PLANNING DIRECTOR'S VARIANCE
1231 "I" STREET, SUITE 200, SACRAMENTO, CA 95814

- APPLICATION:**
- A. Negative Declaration
 - B. Mitigation Monitoring Plan
 - C. Planning Director's Variance Time Extension to reduce the required side yard setback from five feet to three feet on 0.11 ± vacant acres in the Standard Single Family (R-1) zone.

LOCATION: 1832 51st Street

APPLC. NO. P92-126

EXHIBIT A

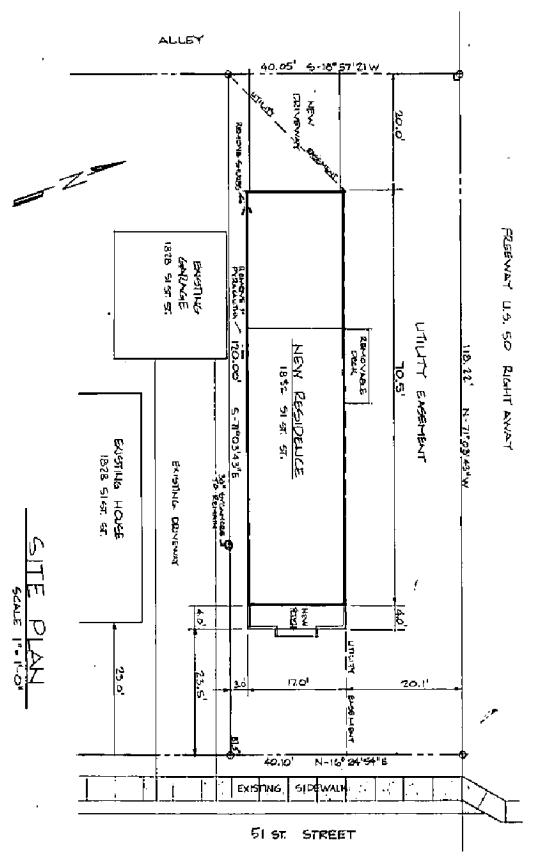
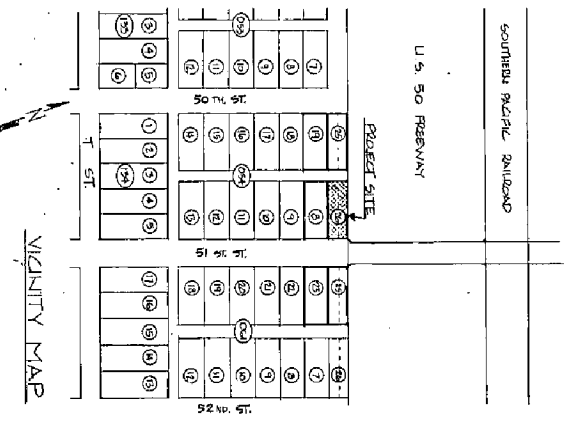
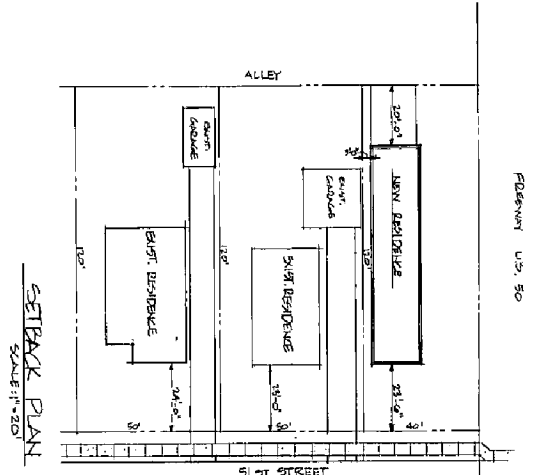
The applicant is proposing to construct a 2,200 square foot, two story single family residence on the subject site. The project utilizes a lot that is substandard in size (see Exhibit A).

Staff has no objections to the applicant's request. The parcel is a very narrow substandard lot adjacent to Highway 50 with a 20 foot utility easement along the north property line. Previously, there was a single family residence on the site that was demolished when Highway 50 was constructed. The applicant proposes to construct a two story single family dwelling on the subject site (see Exhibits B and C). The proposed design for the house is similar to the adjacent residential properties. Allowing the south sideyard setback to be reduced to three feet will permit a house to be built that is seventeen feet wide. There is adequate space between the proposed project and the existing adjacent house. The new structure will be 17.5 feet from the existing house and three feet between garages. Staff supports this reduction because the lot is substandard in width.

EXHIBIT C

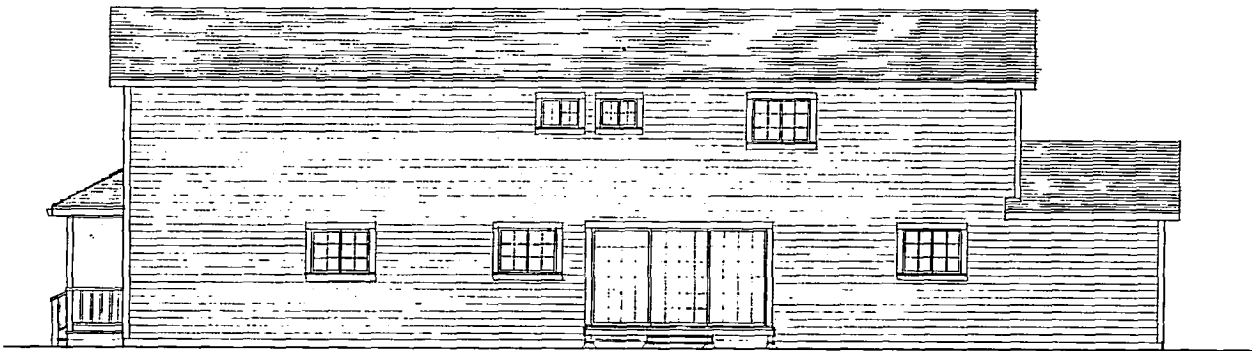
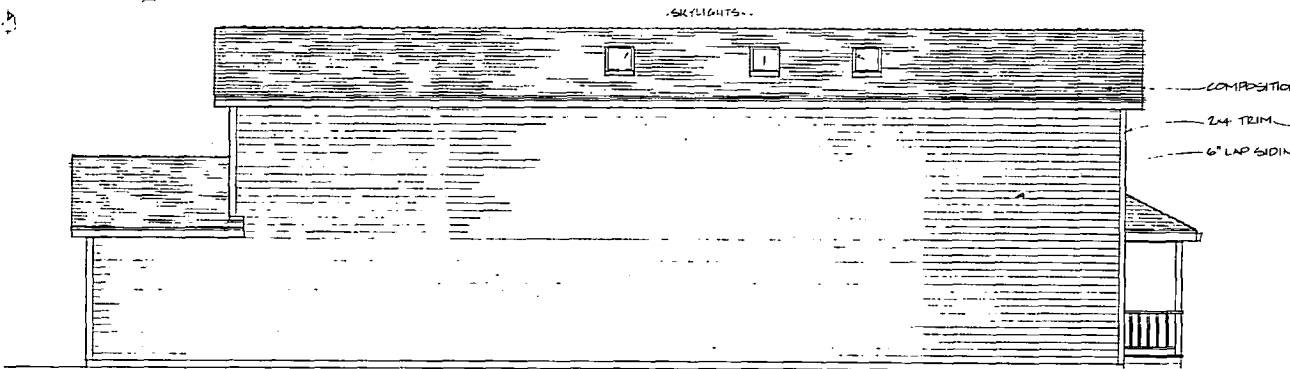
The proposed elevations show horizontal lap siding with a composition shingle roof. Staff recommends a 2x12 wood band painted in the trim color be added to the north and south elevation to align with the first story roof. Staff also recommends the roof be constructed with 25 year laminated dimensional composition shingles and the garage door be a metal sectional door.

- 1. The applicant shall add a 2x12 wood band painted in the trim color to the north and south elevation to align with the first story roof. The roof shall be constructed with 25 year laminated dimensional composition shingles and the garage door shall be a metal sectional door. The elevations shall be revised and submitted to Planning Staff for review and approval prior to the issuance of building permits.
